Addendum No.: 3

Date of Addendum: June 2, 2020

Willard Diloreto Parking Garage
Paul Manafort Sr. Drive
New Britain, CT
CF – RC – 402

The following clarifications are applicable to drawings and specifications for the project referenced above.

4 WALL SECTION
A601 SCALE: 3/8"=1'-0"

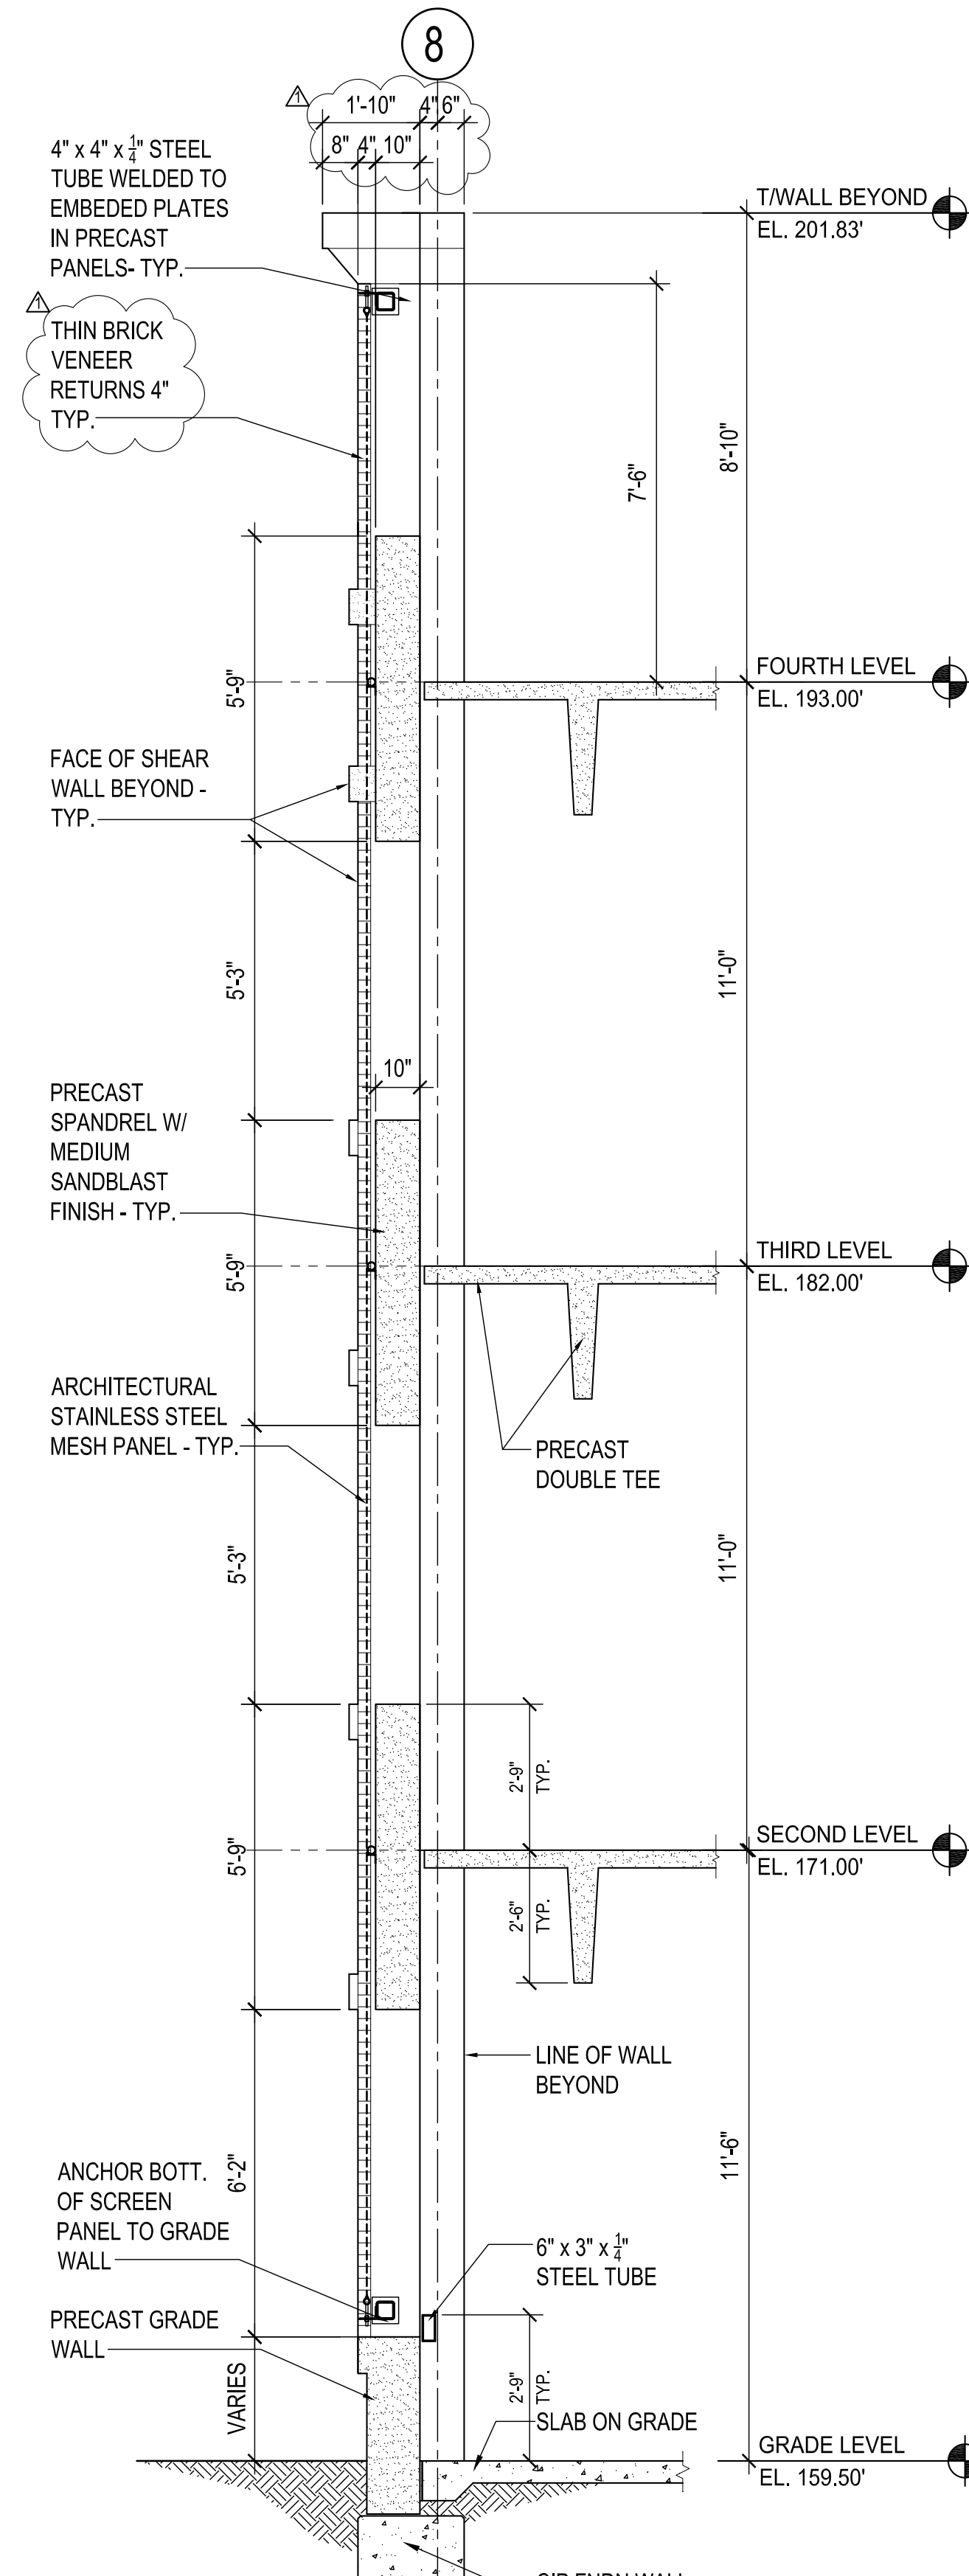
Question: Layout and Elevation Drawings- We do not find any drawings or details that clearly define the edge/end finish of the wall panels with the built-in-pilasters located along the North & South Elevations of the garage. The Elevations show a 'thin brick' finish on the exterior face of the wall panels, but the return portion (edge of panel with built-in-pilaster) is not clearly defined. Detail cuts '2', '3', & '4', from drawing A203, and Wall Section 2 on drawing A601, do not indicate a requirement for thin brick on return portion of the precast wall panels. Please provide a detail showing the finish for the return portion (edge/end of panel with built in-pilaster).

Question: Drawings A201 & A202- Please provide cornice detail at the top of the precast wall panels, centered on grid 2, shown on the North Elevation. Drawing appears to suggest full height vertical precast wall panels with a cornice at the top of the panel and section cuts shown on drawings A601 & A602 seem to indicate precast wall panels to be 12" thick. Based on full height vertical panels and a 12" thickness they become difficult to fabricate, handle and transport. Can the cornice at the top of the panel be a separate piece? Can the panel thickness be reduced to 8" thick? Can a stack of horizontal wall panels be provided in lieu of full height vertical panels?

Question: Drawing A601- Wall Section 3 indicates the shearwalls along grids '1' & '8', as being 1'-2" thick whereas structural drawing S105 indicate shearwalls as 12" thick with 12" thick pilaster. Please advise if the thickness of the shearwalls is to be determined by the precast design engineer or provide the thickness required.

Answer: See revised drawings A203, A402, A407, A409, A601 and A602 showing extents of thin brick and thin brick returns at openings.

Answer: See revised drawings A601 and A602 indicating cornice dimensions.

Answer: The thickness of the shear walls and the inclusion of a pilaster or corbel for the inverted tee girders are to be determined by the precast design engineer. The exterior face and width of the shear walls are to be as per the Drawings.

1
S101
FOUNDATION PLAN
SCALE: 1/16" = 1'-0"

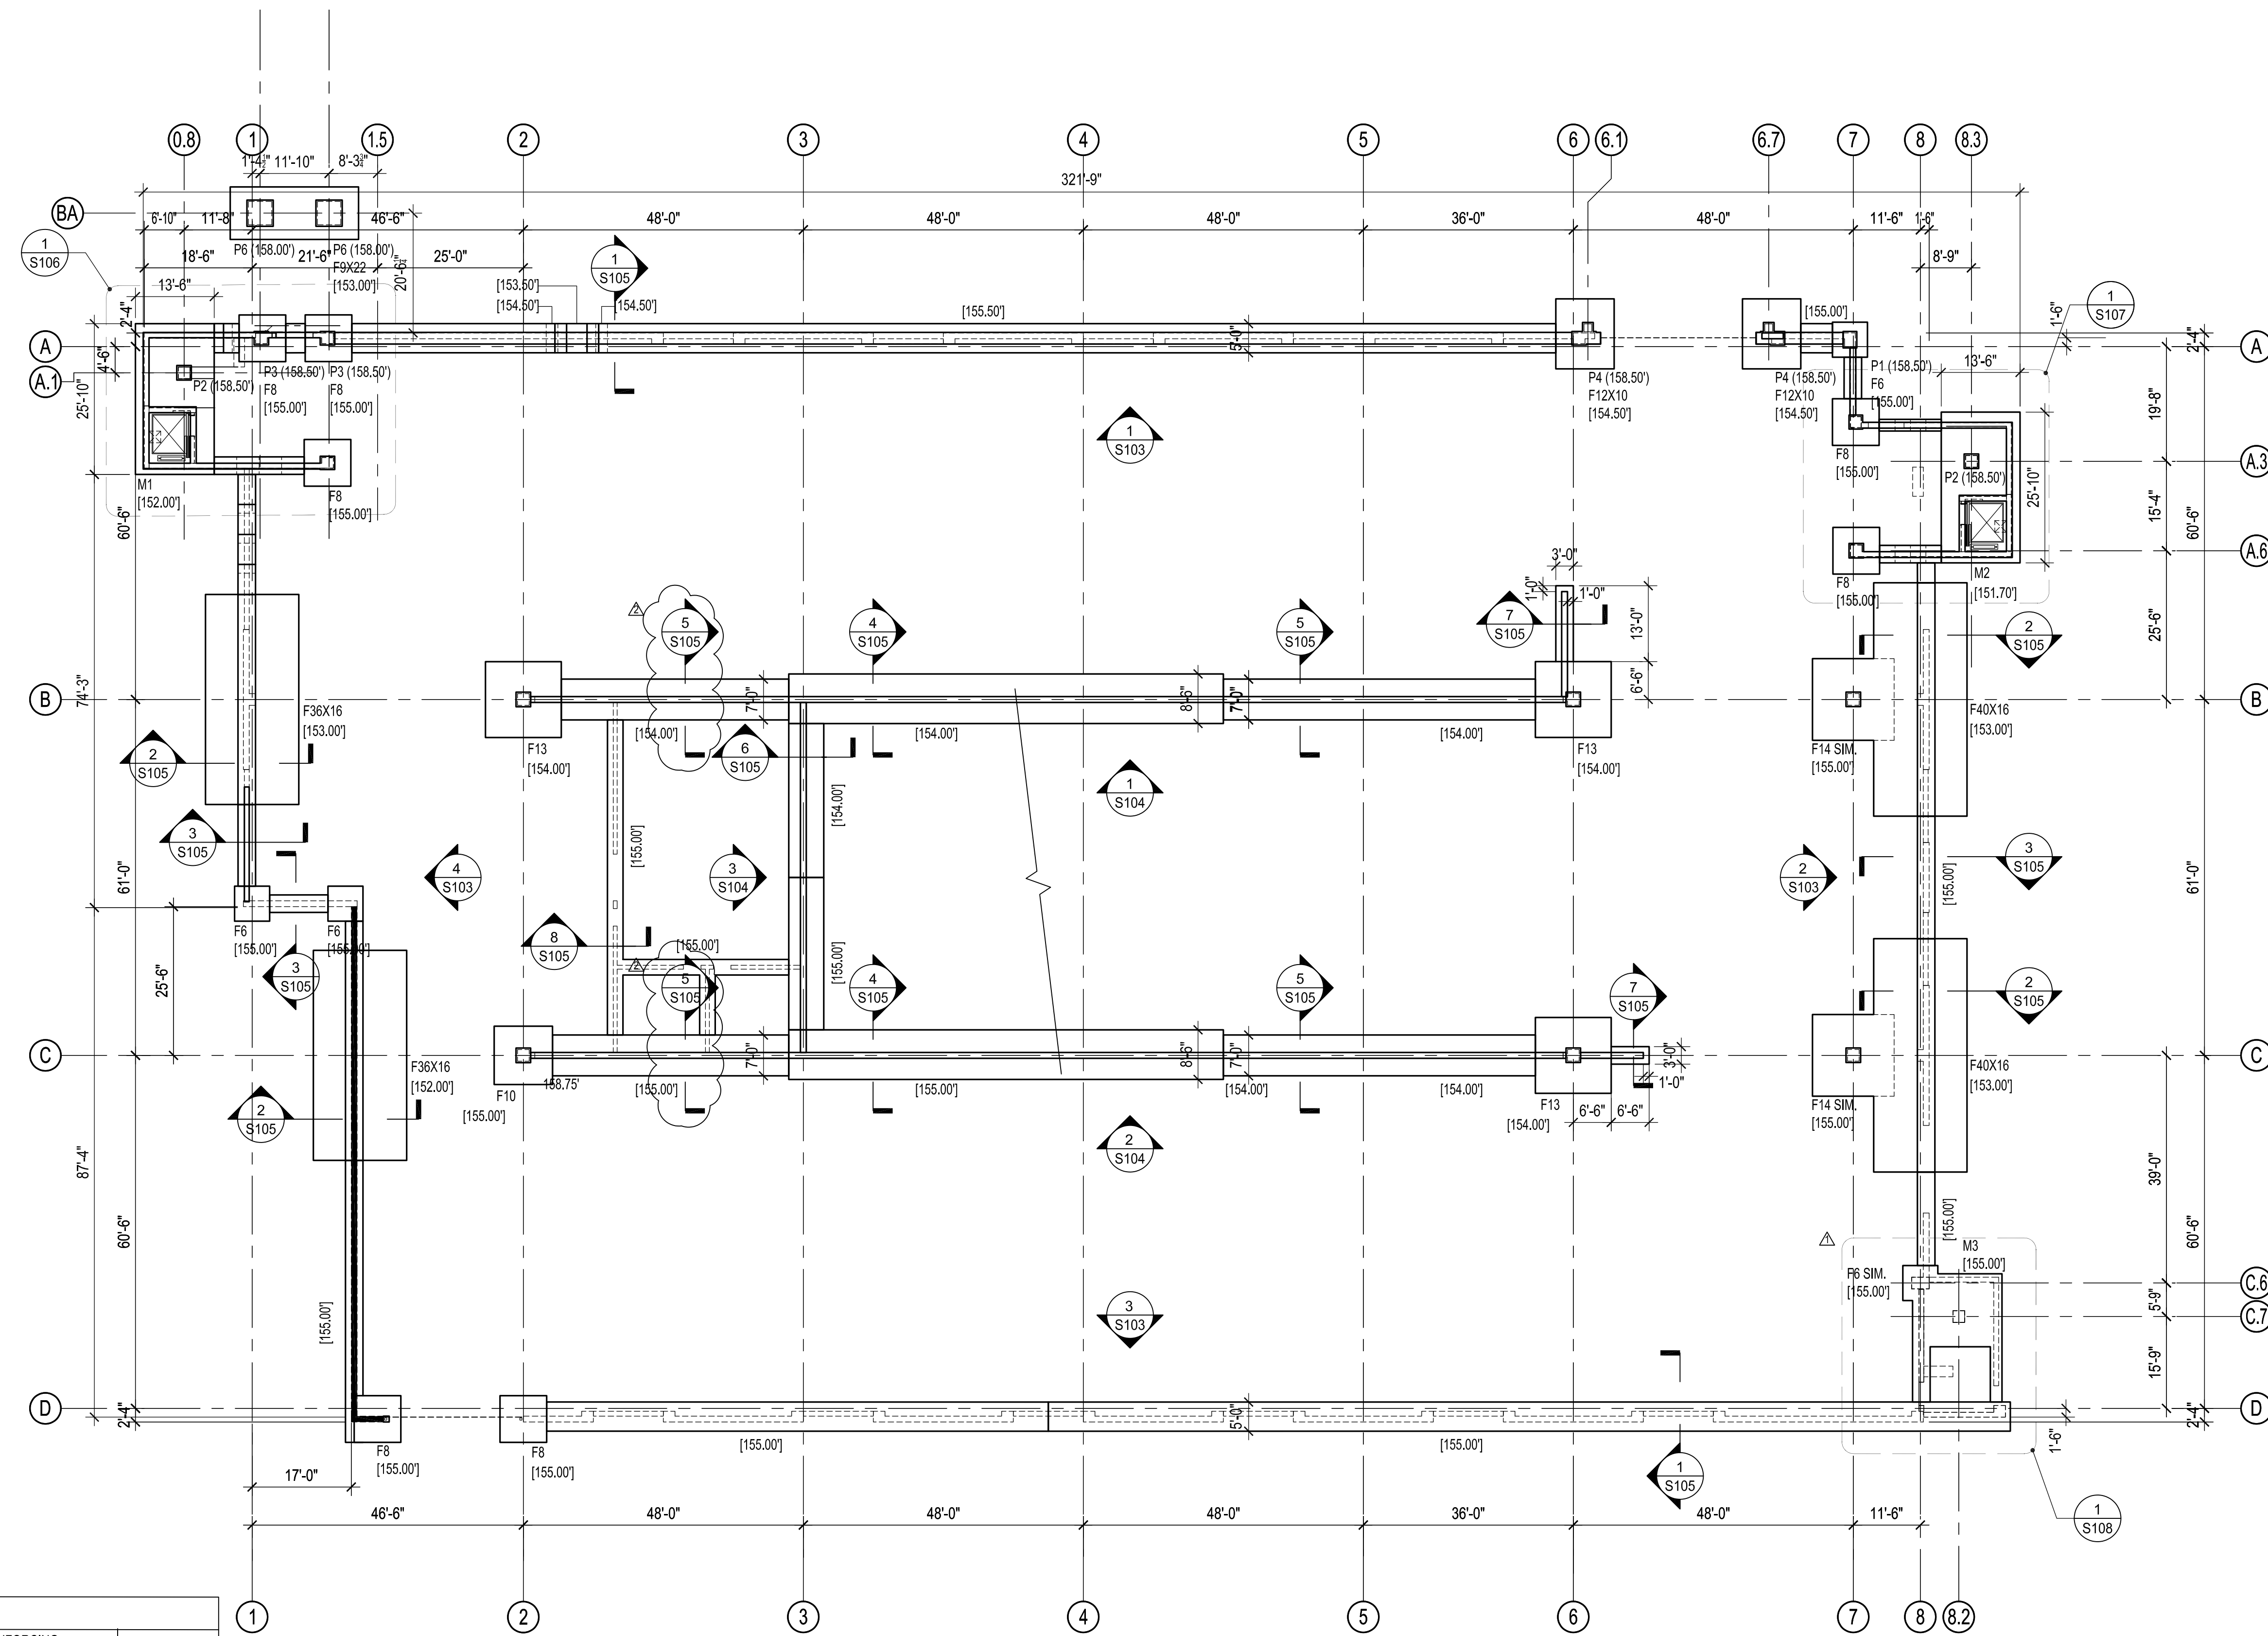
Question: Reference is made to S101 Foundation Plan, Along Column Line B and C between Column 2 and 3 please provide a foundation section.

Answer: See revised drawing S101. Section cuts have been added for walls along B and C lines between column lines 2 and 3.

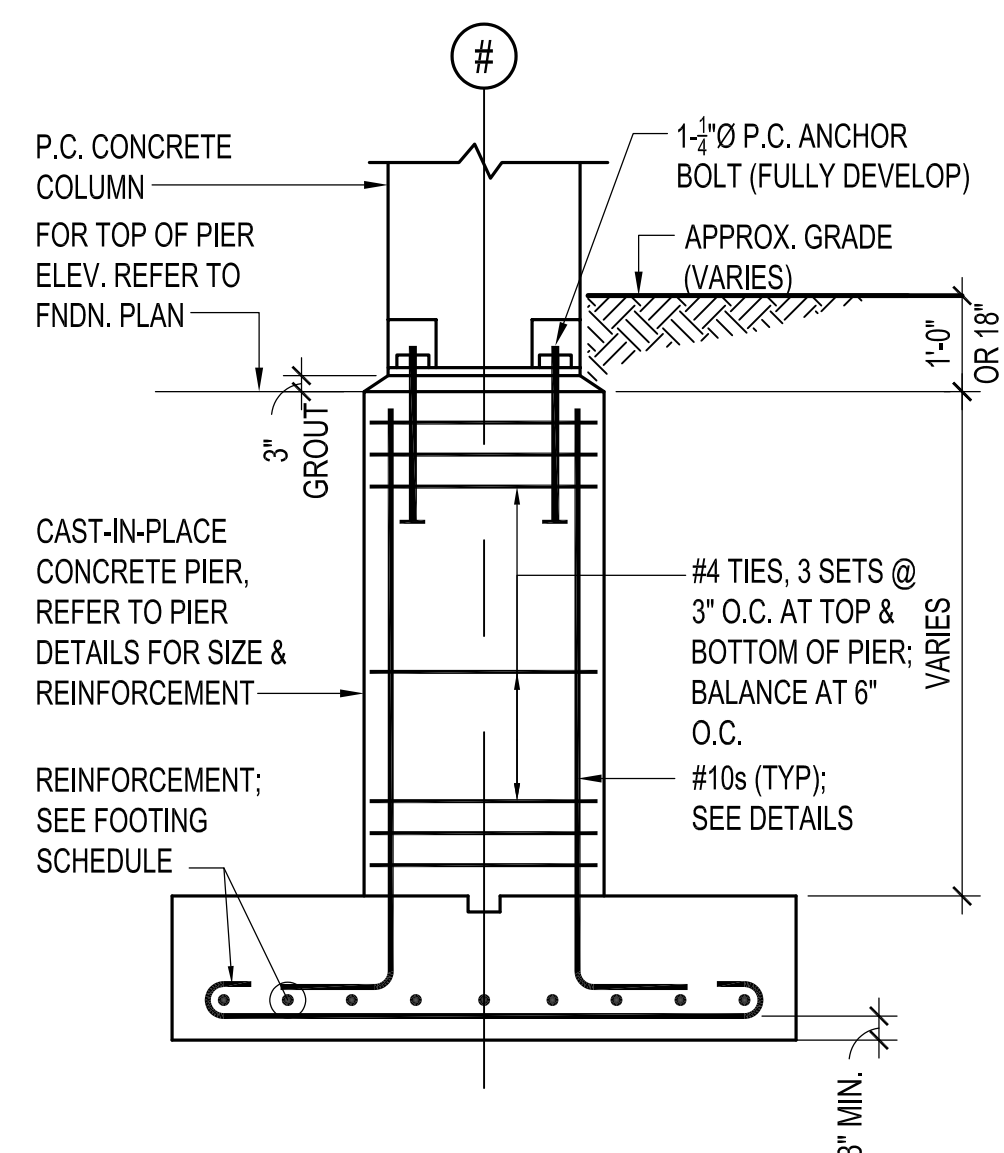
Question: Layout Drawings- We do not find a schedule on any of the drawings, indicating CIP pilaster or precast column sizes. Drawing S302 indicates the precast inverted tee girders at the 'cross over'/end bays as being 3'-0" wide x 3'-0" deep which is the correct size of inverted tee girder for a 48' framing module. The inverted tee girders are supported on precast column corbels and/or built-in column pilaster/corbels on the precast shearwalls. The columns & pilasters are the typically the same 3'-0" width as the inverted tee girder. Drawings appear to indicate 2'-0" square columns by scale, at grids B2, C2, B6, C6, B7, & C7. Please confirm adequate CIP footing/pilaster size will be provided to accommodate a 3'-0" wide precast column and/or a 3'-0" wide built-in column pilaster on precast shearwalls supporting the 3'-0" wide precast inverted girders.

Answer: See revised drawing S102. Column sizes have been added to the pier details. Final precast column sizes will be per the precast engineer's design. Cast in place concrete piers will be adjusted, if necessary, to accommodate the precast column size.
